1960 Corvette: Service Bulletin: Accelerator Pedal Falls Off Retaining Studs

Subject: Accelerator Pedal Falls Off Retaining Studs

Model and Year: 1960 Corvette Models

Source: General Motors of Canada - Service Bulletin

REWORK INSTRUCTION DRAWING TO COVER THE MODIFICATION OF
THE 1960 CORVETTE ACCELERATOR PEDAL # 3771749

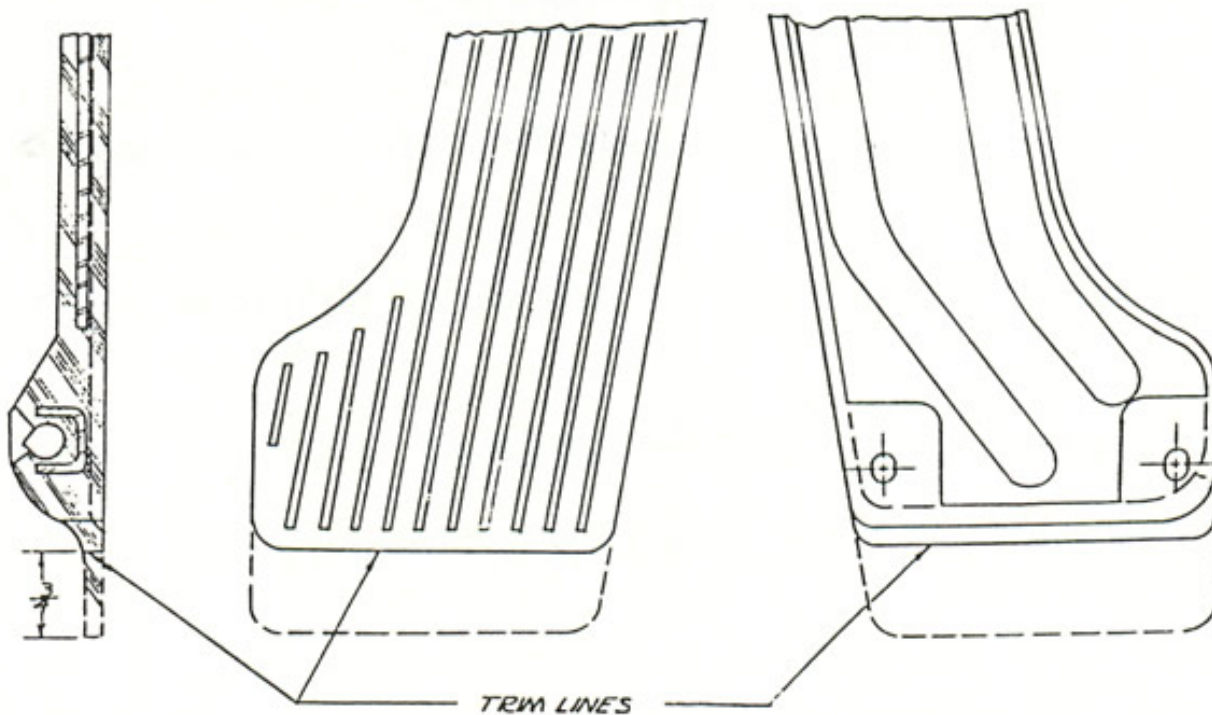
There has been a few complaints that the 1960 Corvette accelerator pedal snaps off of the two retaining studs at the heel end of the pedal, due to an interference condition between the floor mat material and the heel flap of the pedal.

As a Production correction, the assembly plant will revert to the 1959 design pedal, part #3760271, which does not incorporate the heel flap.
